Yelta Solar Farm

Noise Impact Assessment

Project No: MEL3099
Date: 4 March 2022
Revision: 02

1.3 Department of Environment Land, Water and Planning Request for Further Information

Figure 1 Proposed site plan with equipment layout and locations of the nearest noise-sensitive receivers

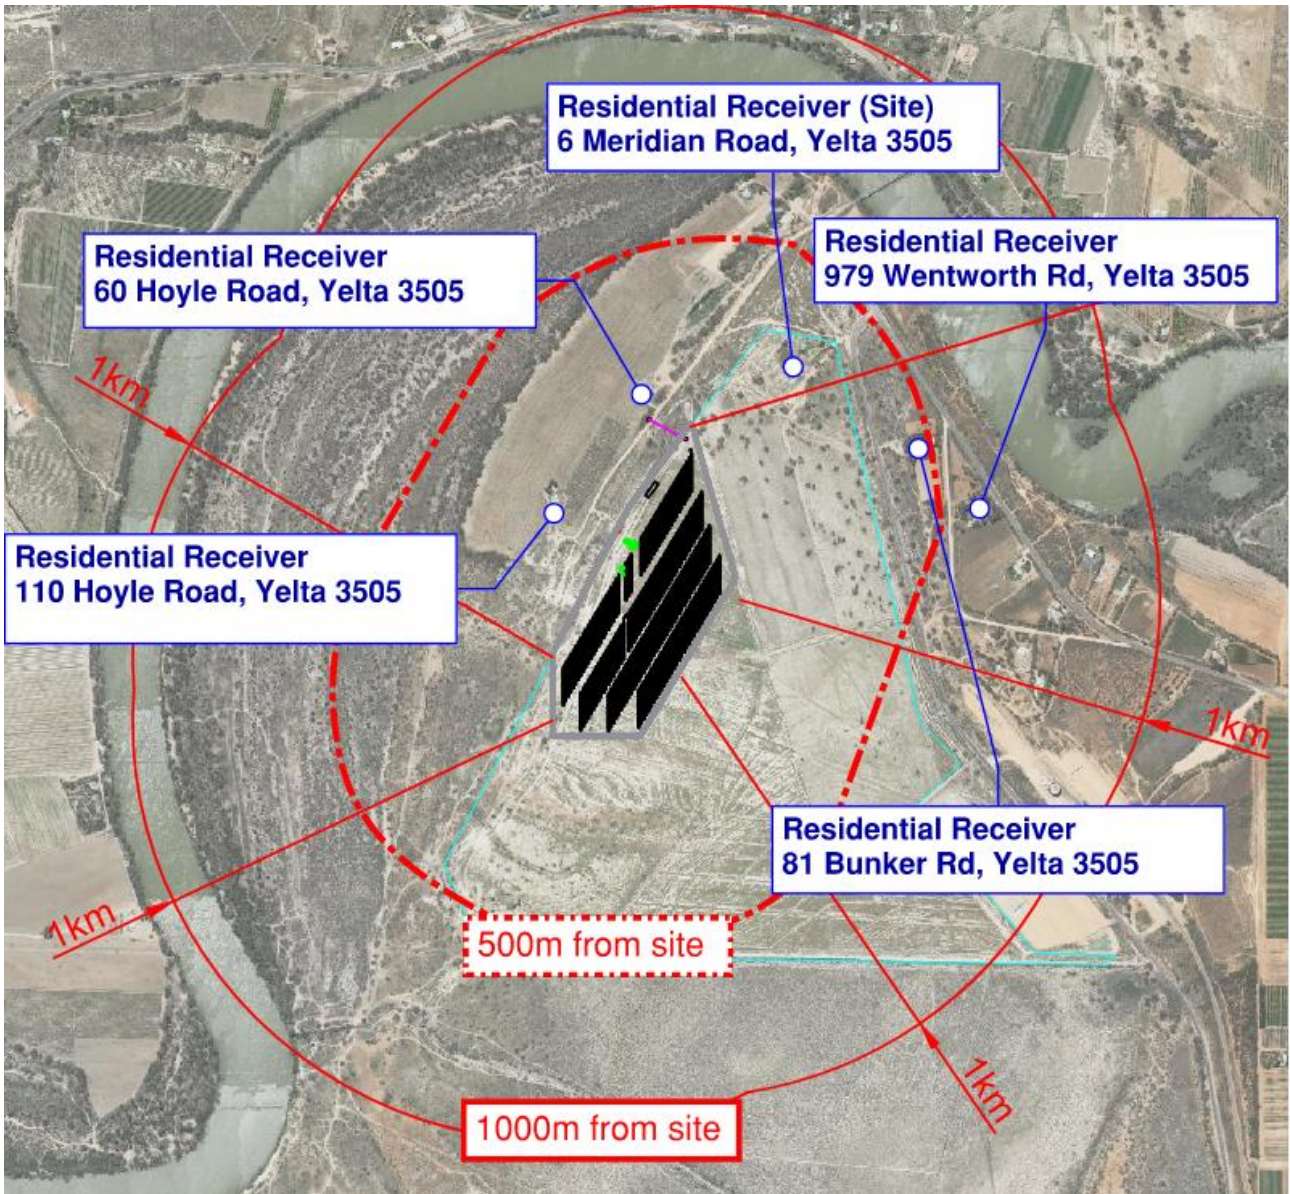
Modelling of noise emissions from the solar farm of all sensitive receivers within 500m of the site.

Please confirm the acoustic assessment covers relevant sensitive receivers to confirm the entire project has been sufficiently considered. The acoustic plans should be updated to demonstrate this.

Sensitive receivers identified in requested boundary have been assessed in Section 3.2.

Figure 1 contains a markup of the site layout with locations of the noise-sensitive receivers.
